SERVICE LETTER NO. 75-10  
"FAA DOA EA-4 APPROVED"

SUBJECT: PARKING BRAKE IMPROVEMENT

SERIALS AFFECTED: All Model AA-1, AA-1A and AA-5, AA1B-0001 thru AA1B-0582, AA5A-0001 thru AA5A-0058 and AA5B-0001 thru AA5B-0179.

Figure 1. Parking Brake Improvement

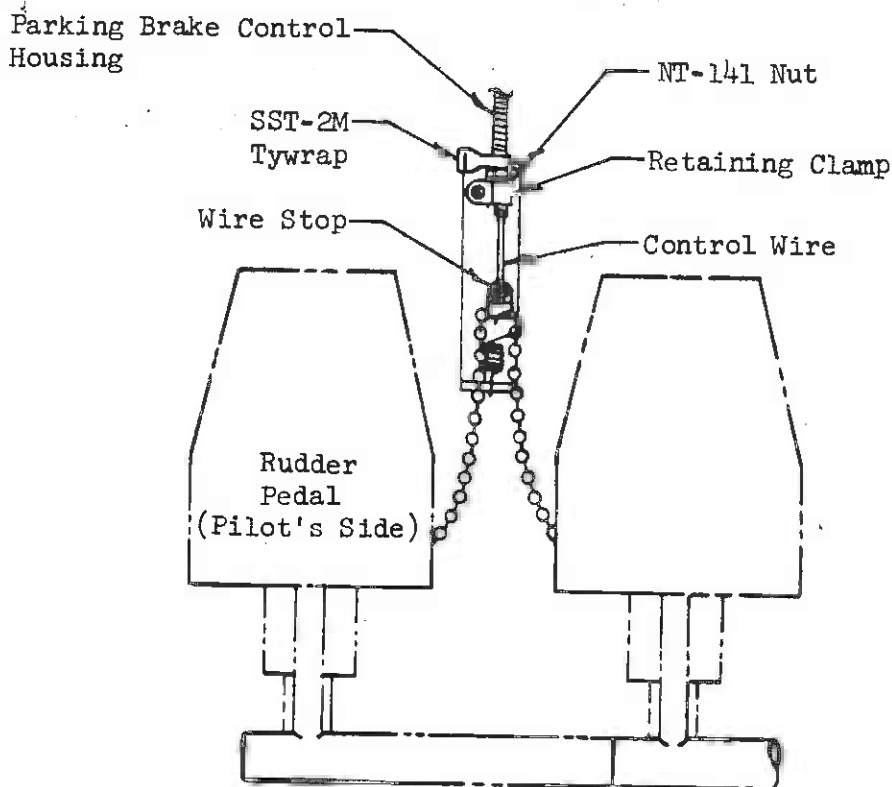
Recent production aircraft have incorporated an engineering change that provides for increased retention of the parking brake control housing. Field reports indicate that in some instances, the housing would slip through the retaining clamp, when the parking brake control was actuated. Therefore, a nut and associated tywrap lock have been added directly above the clamp.

1. Loosen screw on wire stop, straighten parking brake control wire and remove wire stop.

2. Loosen retaining clamp sufficiently to allow the housing to slide through.
3. Install NT-141 Nut on housing, reassemble in the reverse order and rig parking brake.

4. Seat NT-141 Nut on retaining clamp and install SST-2M Tywrap to prevent nut from turning.
5. Check parking brake for proper operation. After disengaging, apply full rudder pedal deflection in both directions and confirm that neither master cylinder parking brake lever is lifting.
